Project	<b>IEEE 802.16 Broadband Wireless Access Working Group</b> < <a href="http://ieee802.org/16">http://ieee802.org/16</a> >	
Title	<b>Modified DL subcarrier to resource unit mapping</b>	
Date Submitted	<b>2008-07-16</b>	
Source(s)	<p>Taeyoung Kim Jeongho Park Junsung Lim Jaeweon Cho Hokyung Choi Heewon Kang</p> <p>Samsung Electronics</p> <p>Sophie Vrzic Dongsheng Yu Mo-Han Fong Robert Novak Steve Yuan Hosein Nikopourdeilami</p> <p>Nortel</p> <p>Jong-kae (JK) Fwu Hujun Yin Huaning Niu Yuval Lomnitz Sassan Ahmadi</p> <p>Intel Corp.</p> <p>HanGyu Cho Jinsoo Choi Bin-chul Ihm</p> <p>LG Electronics</p>	<p><a href="mailto:ty33.kim@samsung.com">ty33.kim@samsung.com</a>, <a href="mailto:jeongho.jh.park@samsung.com">jeongho.jh.park@samsung.com</a>, <a href="mailto:junsung.lim@samsung.com">junsung.lim@samsung.com</a> <a href="mailto:jaeweon.cho@samsung.com">jaeweon.cho@samsung.com</a>, <a href="mailto:choihk@samsung.com">choihk@samsung.com</a> <a href="mailto:hkang@samsung.com">hkang@samsung.com</a></p> <p><a href="mailto:svrzic@nortel.com">svrzic@nortel.com</a> <a href="mailto:dongshengyu@nortel.com">dongshengyu@nortel.com</a> <a href="mailto:mhfong@nortel.com">mhfong@nortel.com</a> <a

Figure 1 – Example for proposed DL subcarrier to resource unit mapping structure

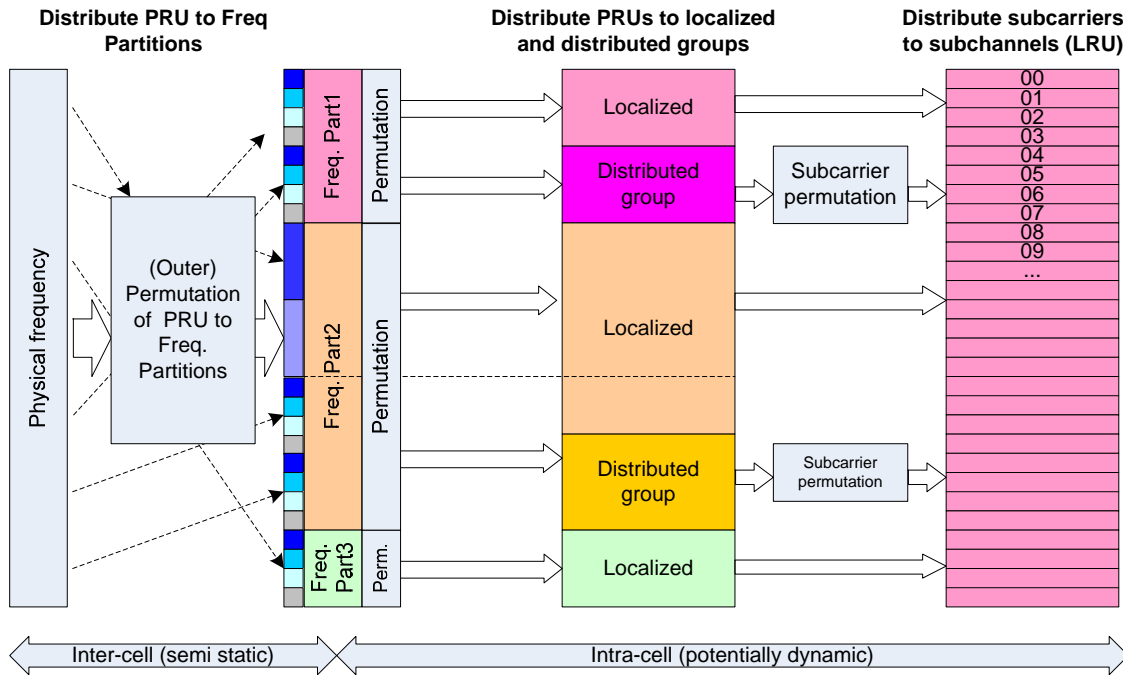
In order to meet the requirements mentioned above, a modified DL subcarrier to resource unit mapping is proposed as described in Figure 1.

- First-level or outer permutation is applied to the PRUs in the units of N1 and N2 PRUs, where N1 =4 (TBD) and N2 =1 or 2 depending on system bandwidth (TBD). Direct mapping of outer permutation can be supported.
- Distributed PRUs into frequency partitions.
- The frequency partition is divided into localized(LLRU) and/or distributed(DRU) resources for each resource Using sector specific permutation can be supported; directly mapping of the resources can be

supported for localized resource. The sizes of the groups are flexibly configured per sector (TBD). Adjacent sectors do not need to have same configuration of localized and distributed resources.

- The localized and distributed groups are further mapped into LRUs (by direct mapping of LLRU and by “Subcarrier permutation” on DRUs) as shown in the following figure.

Figure 1 Illustration of the downlink subcarrier to resource block-unit mapping

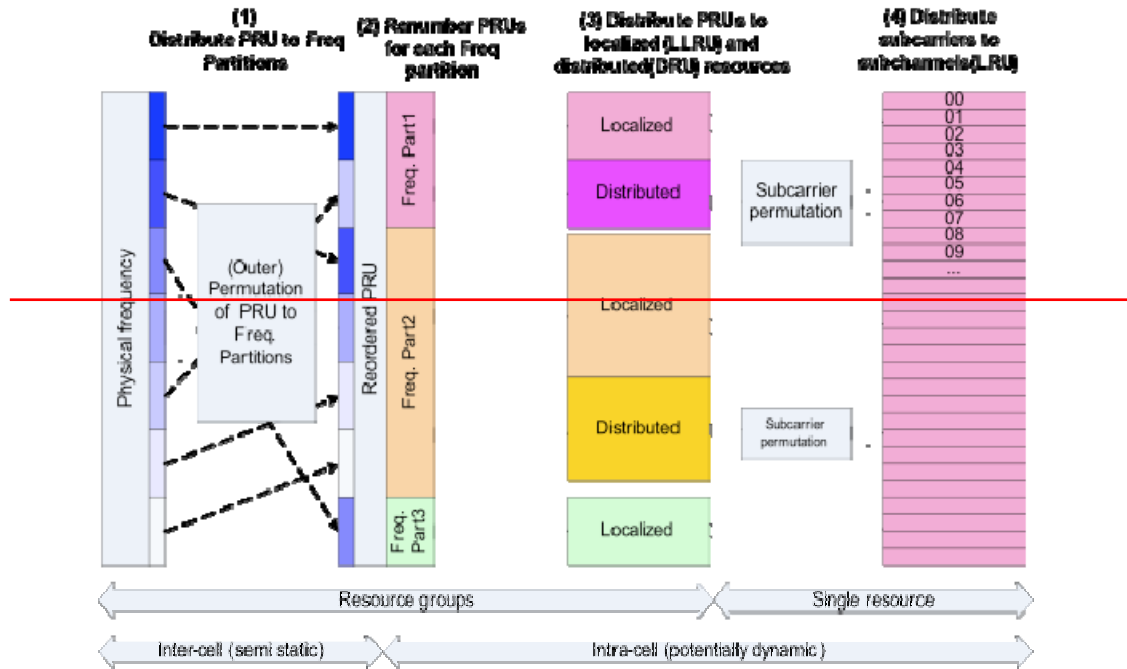
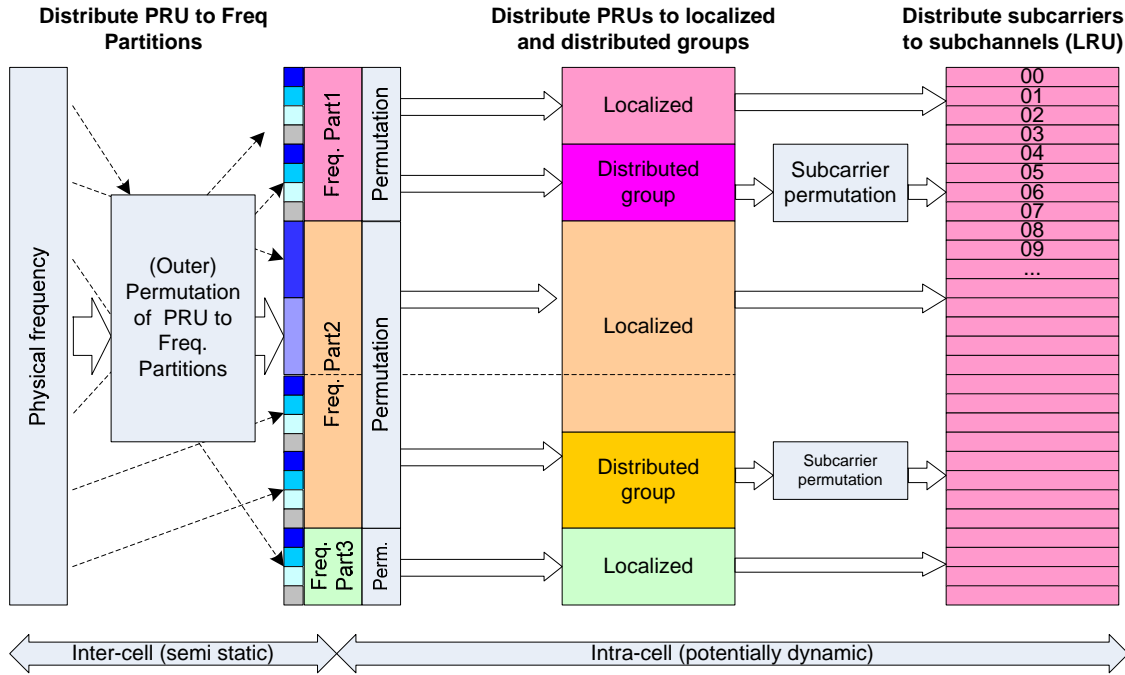
*Change the text in Downlink subcarrier to resource unit mapping Sub-clause as follows:*

1. First-level or outer permutation is applied to the PRUs in the units of  $N1$  and  $N2$  PRUs, where  $N1 = 4$  (TBD) and  $N2 = 1$  or  $2$  depending on system bandwidth (TBD). Direct mapping of outer permutation can be supported.
2. Distributed PRUs into frequency partitions.

3. The frequency partition is divided into localized(LLRU) and/or distributed(DRU) resources for each resource ~~using the PRU as unit for each resource~~. Using sector specific permutation can be supported; directly mapping of the resources can be supported for localized resource. The sizes of the groups are flexibly configured per sector (TBD). Adjacent sectors do not need to have same configuration of localized and distributed resources. ~~diversity groups~~.
4. The localized and distributed groups are further mapped into LRUs (by direct mapping of LLRU and by “Subcarrier permutation” on DRUs) as shown in the following figure.
